Subject: AP1000 Response to Request for Additional Information (SRP 3)

RAI-SRP3.7.1-SEB1-11 R2

# AP1000 TECHNICAL REPORT REVIEW

RAI Response Number: RAI-SRP3.7.1-SEB1-11

## Response to Request For Additional Information (RAI)

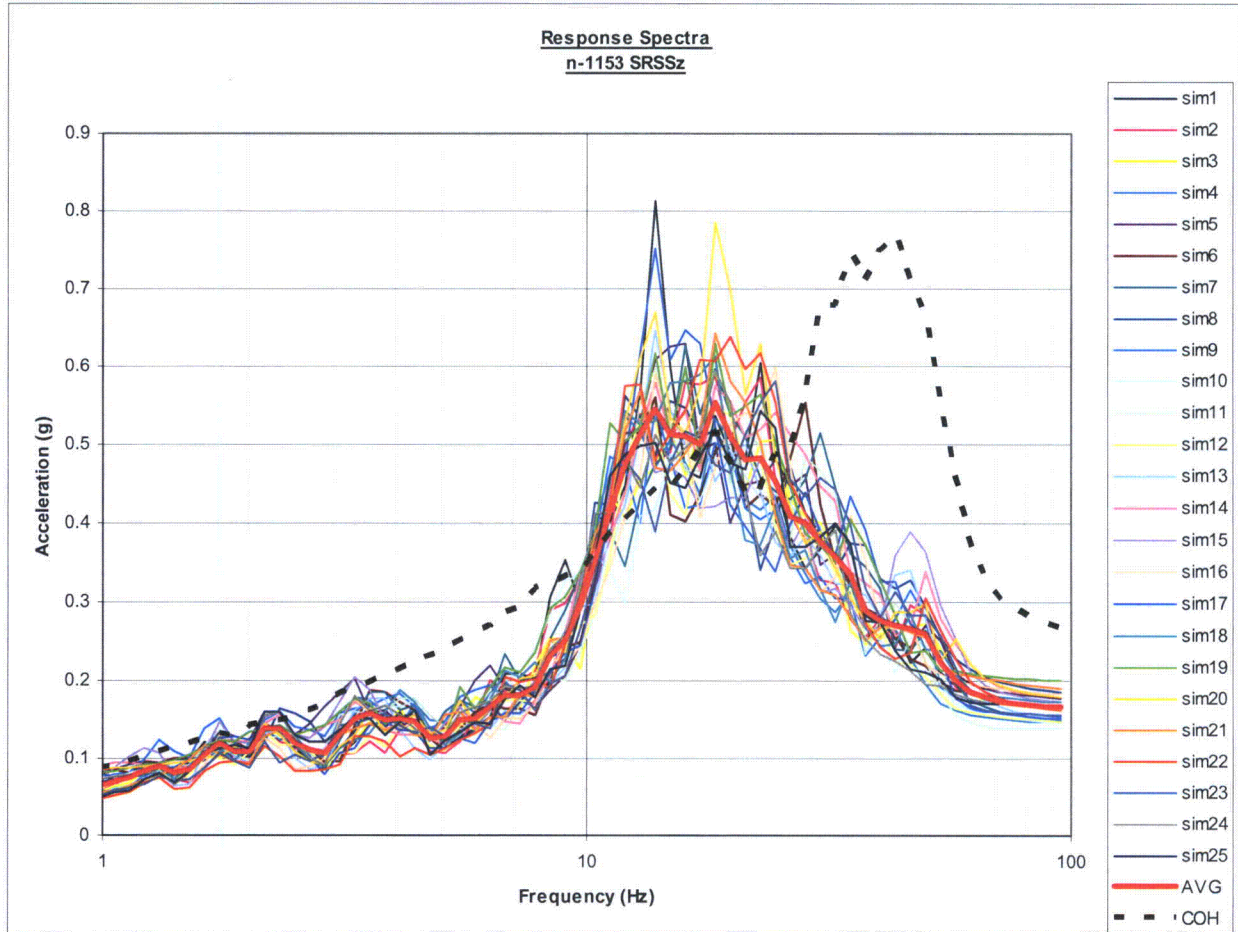
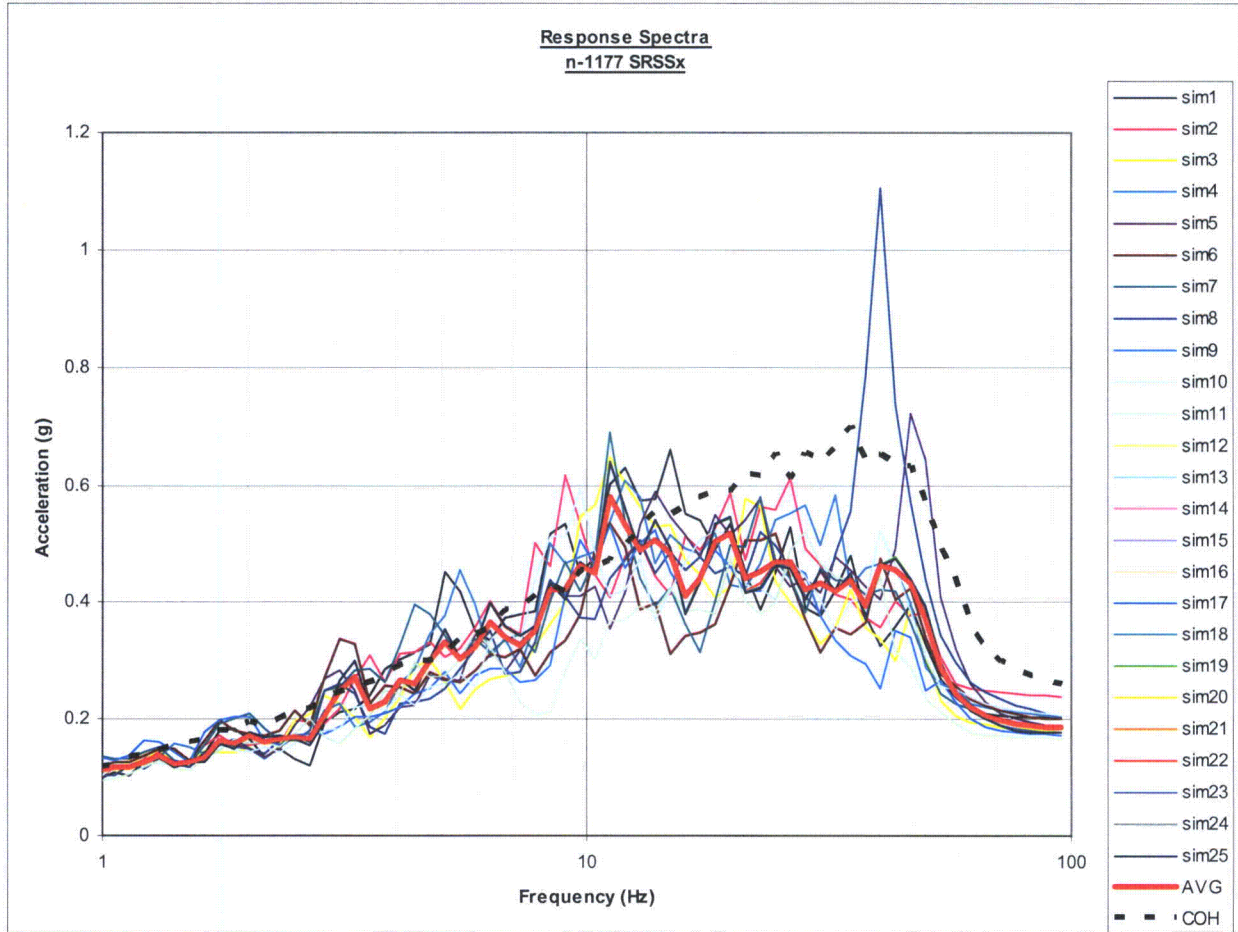
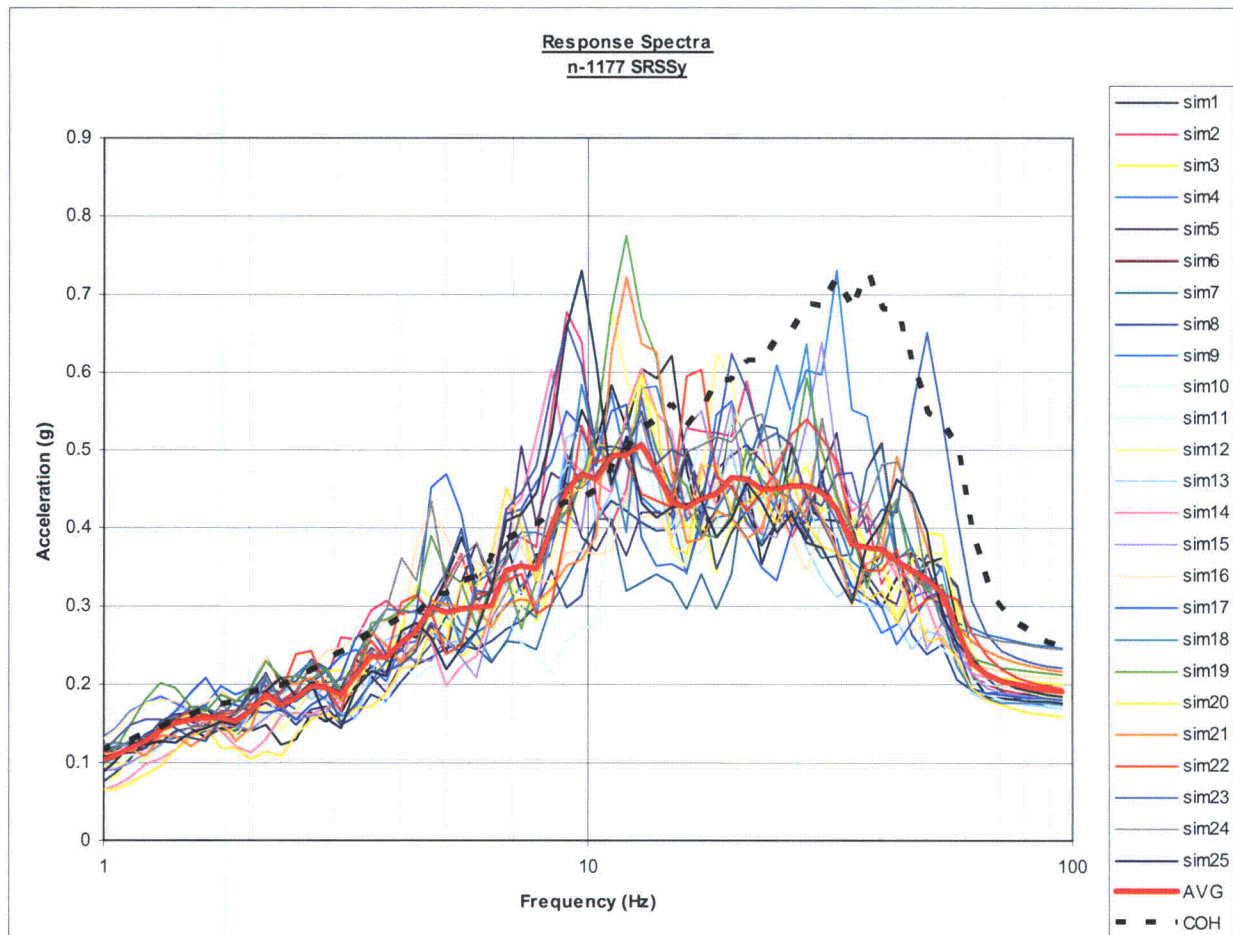
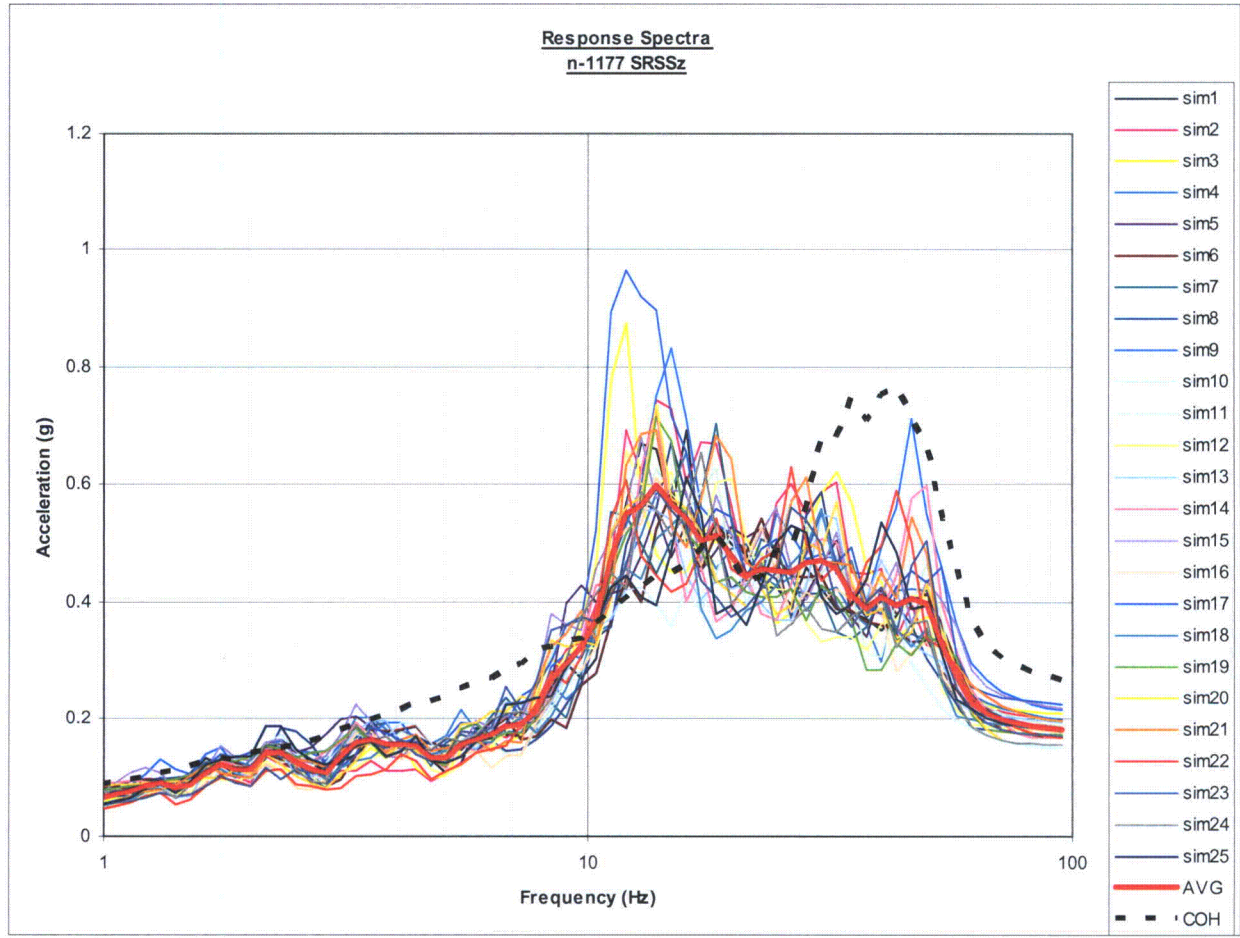
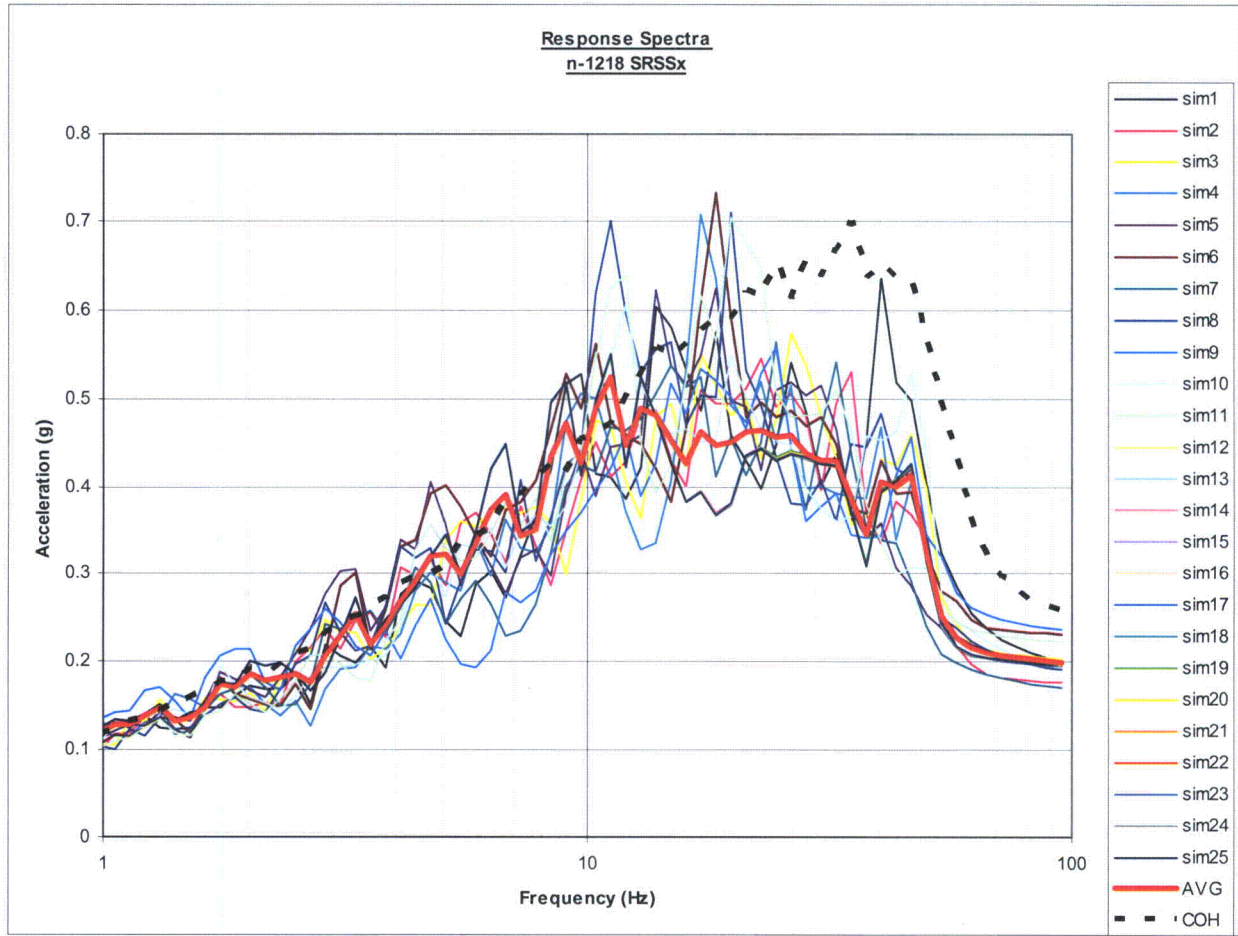
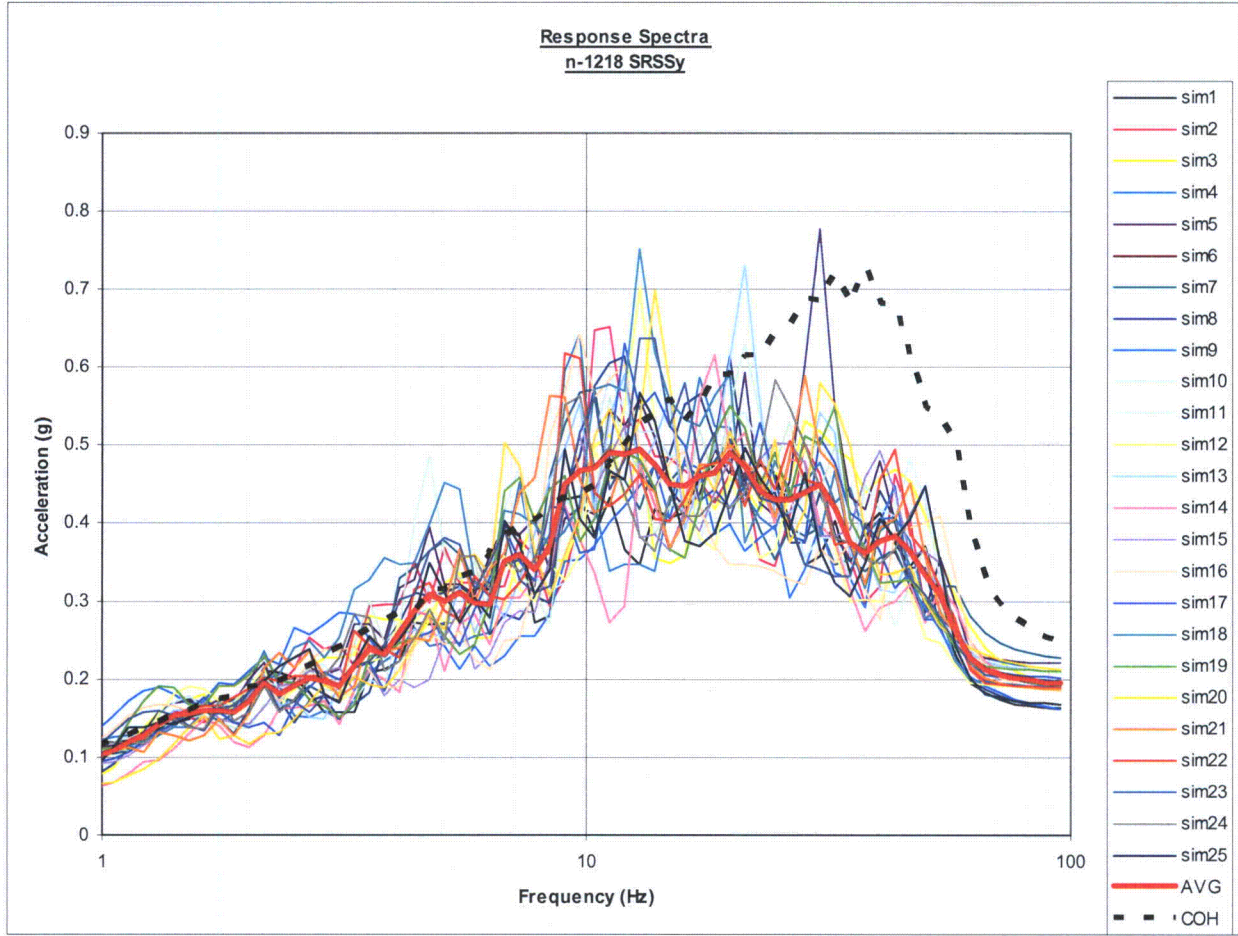
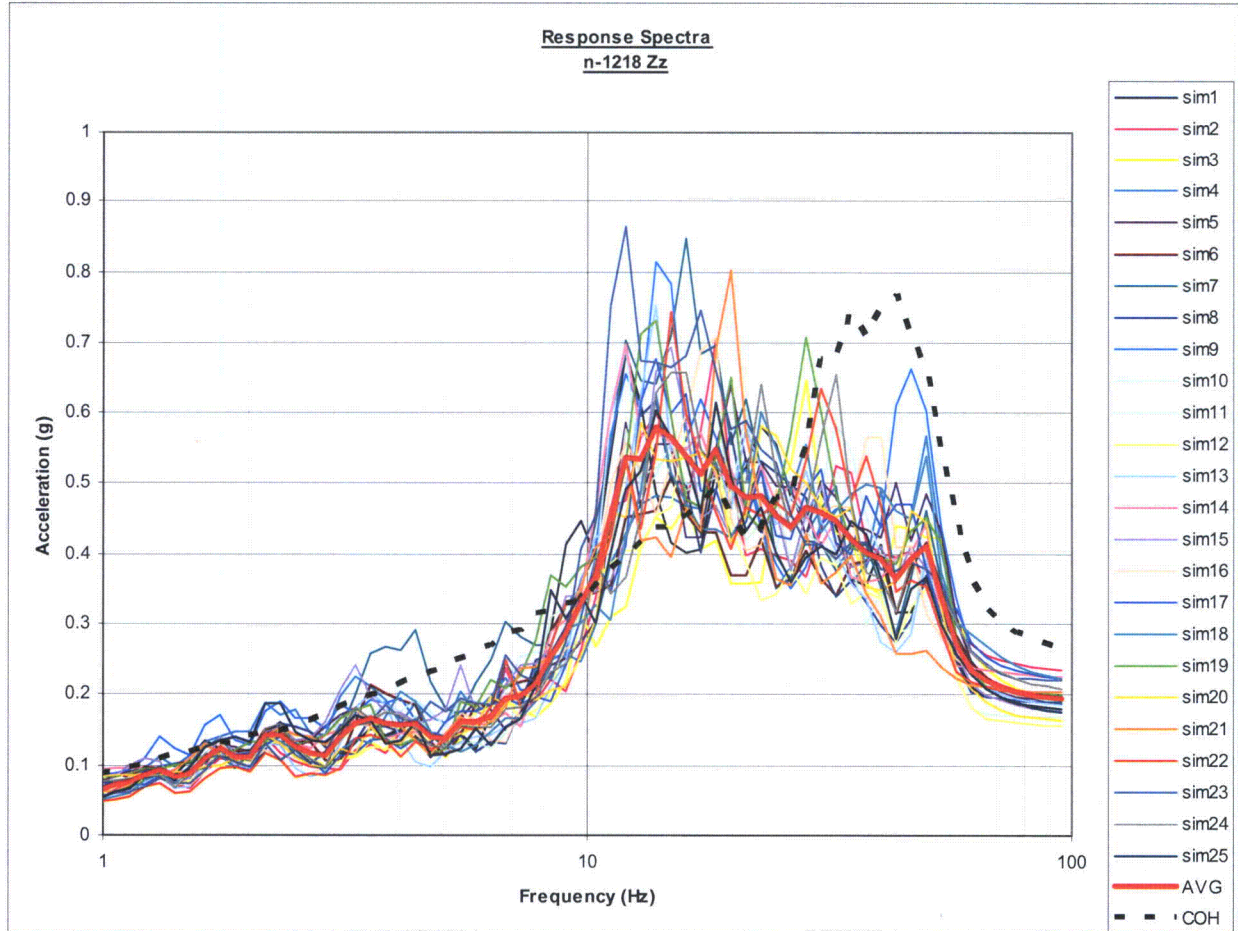
More data, i.e., HRHF response spectra for 5 locations on the basemat (4 locations at 4 corner and center) comparison of coherent at 5 nodes, 25 samples of incoherent and average of 25 incoherent response spectra.

Following the NRC Audit of AP1000 Seismic Design the week of April 13-17, 2009, the NRC has requested additional HRHF FRS at the four corners and center of the Nuclear Island basemat. The nodal locations of the response spectra comparisons have been provided in a plot shown in Figure RAI-SRP3.7.1-SEB1-11-10. A comparison of the SRSS combined X, Y and Z directions for incoherent simulations, average incoherent and coherent FRS are shown in Figures RAI-SRP3.7.1-SEB1-11-11 through RAI-SRP3.7.1-SEB1-11-25. The plots provided show a general reduction in the 25 incoherent simulations when compared to the coherent response in the higher frequencies. At lower elevations, the incoherent simulations exceed the coherent responses in the z-direction around the 10-20 Hz range; these exceedances do not exist at higher elevations as seen in Figures RAI-SRP3.7.1-SEB1-11-1 through RAI-SRP3.7.1-SEB1-11-9.
